Roosevelt Lofts – Historic Rehabilitation & New Apartments – 22-3281

ADDENDUM NO. 1

1-HOUR RATED FULL HGT
NON-RATED FULL HGT

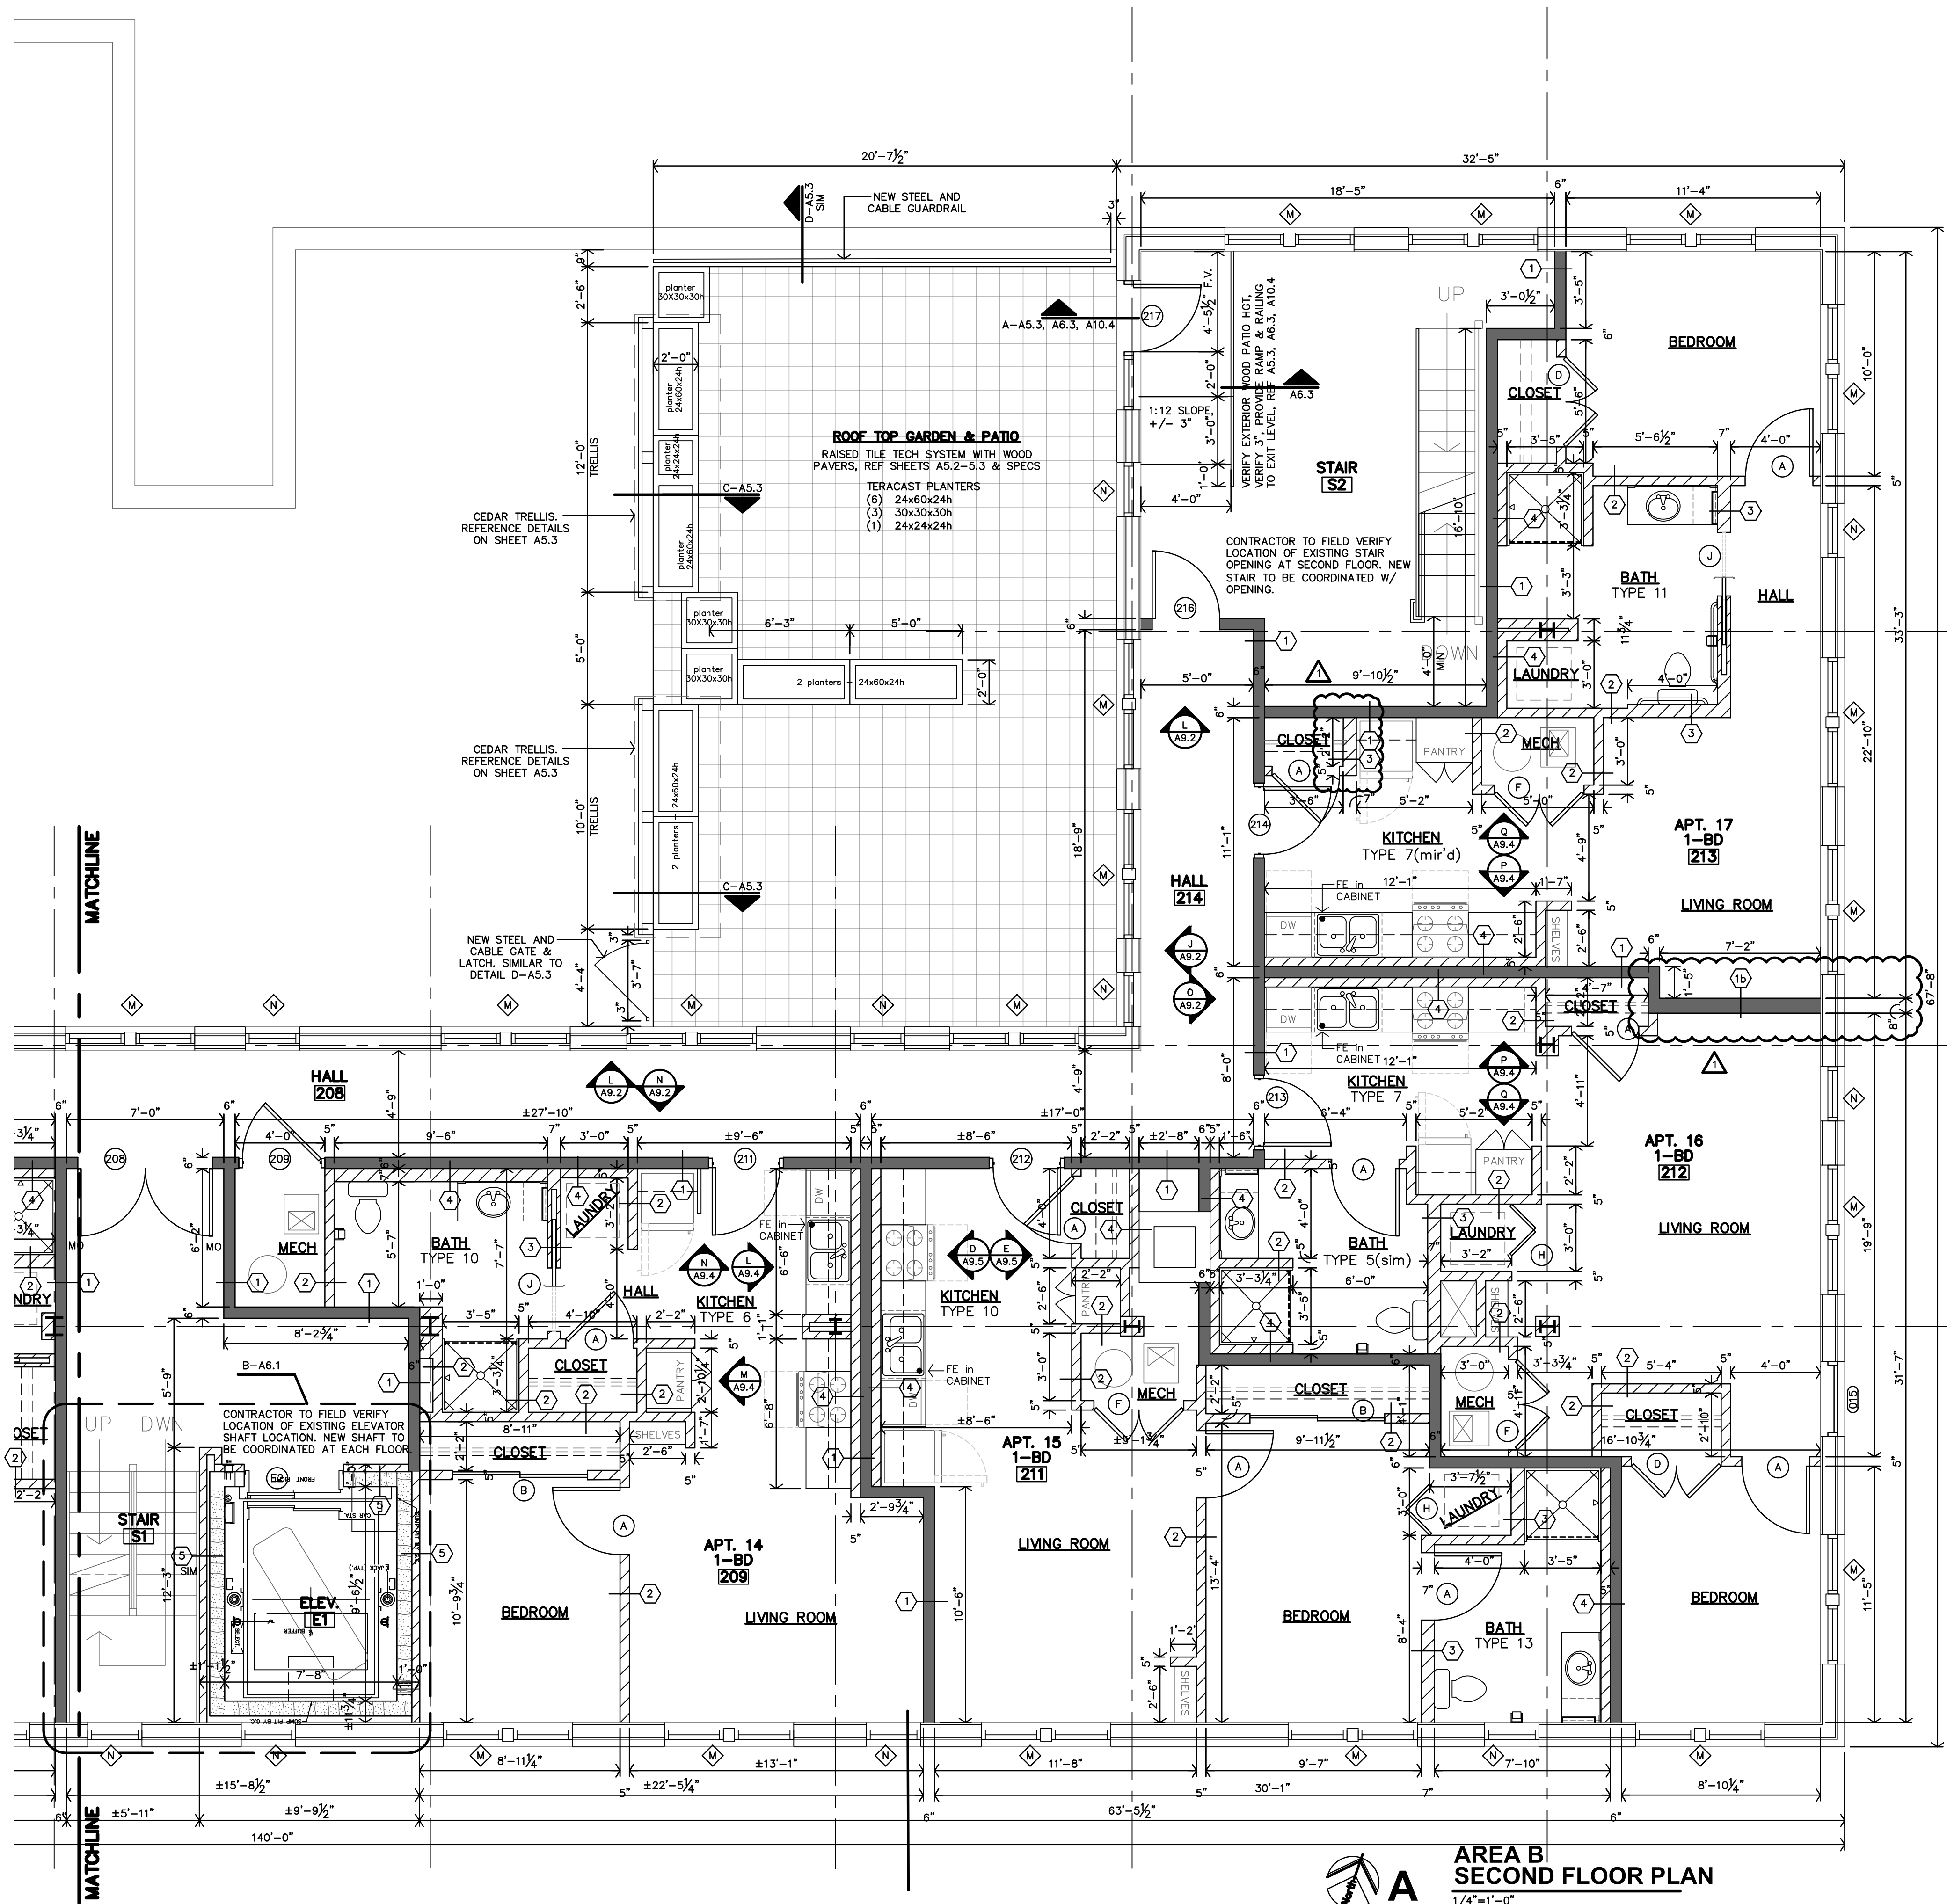
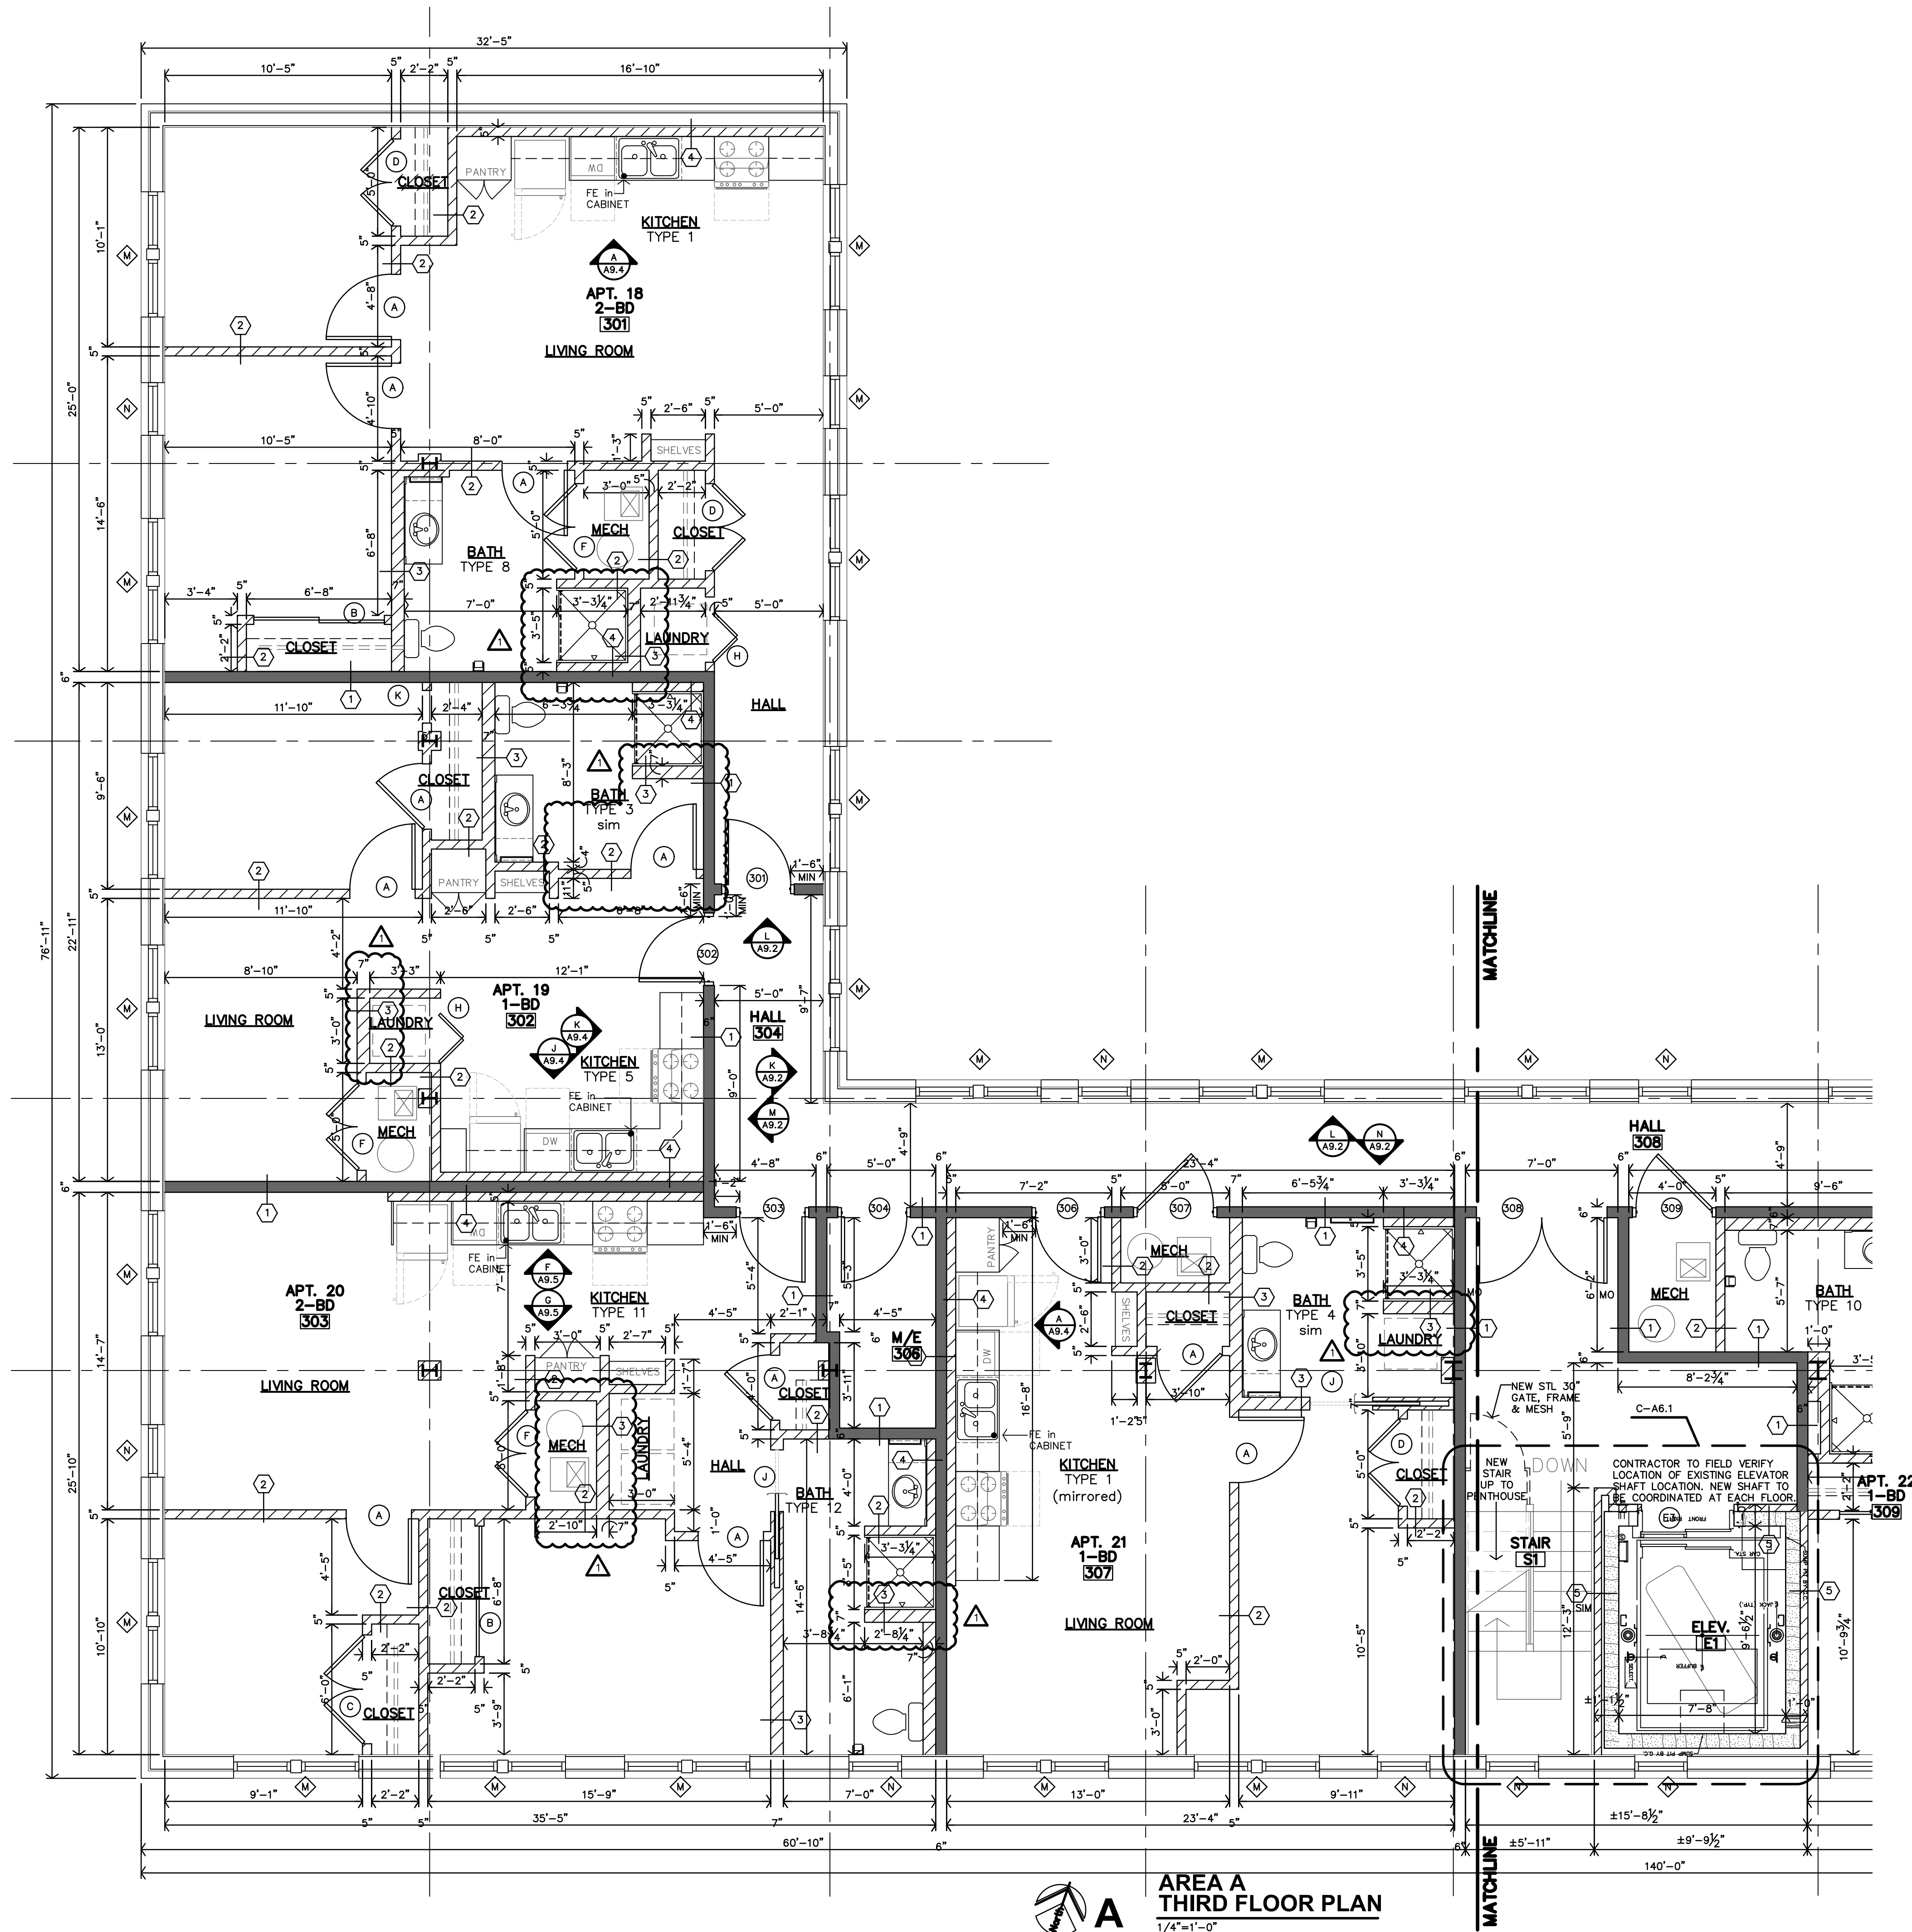
- b. Add wall Type 1B
5. Sheets A2.3 – A2.8 – Several places where walls have been thickened to a 2x6 stud vs. a 2x4 to allow for plumbing and vent ducts to route up through them.

- a. Unit 112 – wall behind Laundry has been changed to a Type 3
 - b. Unit 113 – wall in-between Laundry and Mech has been changed to a Type 3
 - c. Unit 114 – wall in-between Laundry and shower has been changed to a Type 3

- d. Unit 122 – wall behind Laundry has been changed to be 7" thick vs. 5" thick.
 - e. Unit 123 – wall behind Laundry has been changed to be 7" thick vs. 5" thick

- f. Unit 127 – wall behind Laundry has been changed to be 7" thick vs. 5" thick
 - g. Unit 201 – wall in-between Laundry and Shower has been changed to a Type 3

- h. Unit 202 – wall behind Laundry has been changed to a Type 3
 - i. Unit 203 – wall in-between Laundry and Mech has been changed to a Type 3
 - j. Unit 207 – wall in-between Laundry and Shower has been changed to a Type 3

- k. Unit 212 – portion of wall in-between Units 212 & 213 has been changed to a Type 1B

- l. Unit 213 – wall in-between closet and refrigerator has been changed to a Type 3
 - m. Unit 301 – wall in-between shower and laundry has been changed to a Type 3

- s. Unit 313 – wall in-between closet and refrigerator has been changed to a Type 3. Wall in-between shower and vanity has been changed to a Type 3.
6. Sheet A3.1
